Technical Service Bulletin (TSB)
Seat Belt Height Adjuster

REFERENCE:	TSB: 10-001-24 GROUP: 10 - Restraints	Date:	January 13, 2024	REVISION:	10-002-23
VEHICLES AFFECTED:	**2023 (MV) Jeep Compass** This bulletin applies to vehicles built on or after August 23, 2023 (MDH 0823XX) and on or before **September 30, 2023 (MDH 0930XX)**.			MARKET APPLICABILITY:	
				<input type="checkbox"/> NA	<input checked="" type="checkbox"/> MEA
				<input type="checkbox"/> SA	<input type="checkbox"/> IAP
				<input checked="" type="checkbox"/> EE	<input type="checkbox"/> CH
CUSTOMER SYMPTOM:	Customers may experience the seat belt position adjuster will not adjust to the maximum height position.				
CAUSE:	Incorrectly installed upper B-Pillar trim panel retaining clip.

Fig. 1
B-Pillar Clip

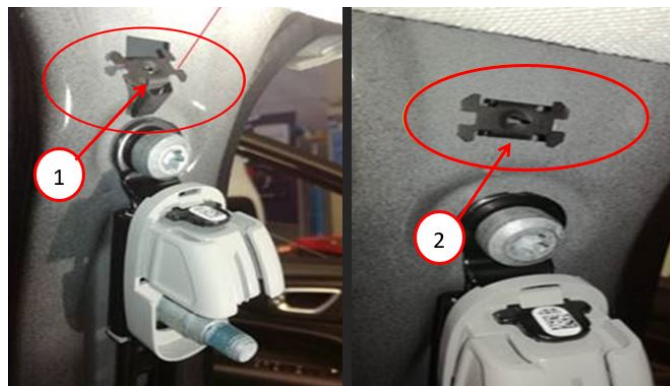
NOTE: Confirm the upper B-Pillar trim panel clips are installed properly [Fig. 1](#).

- 1 - Improperly Installed B-Pillar Clip
2 - Properly Installed B-Pillar Clip
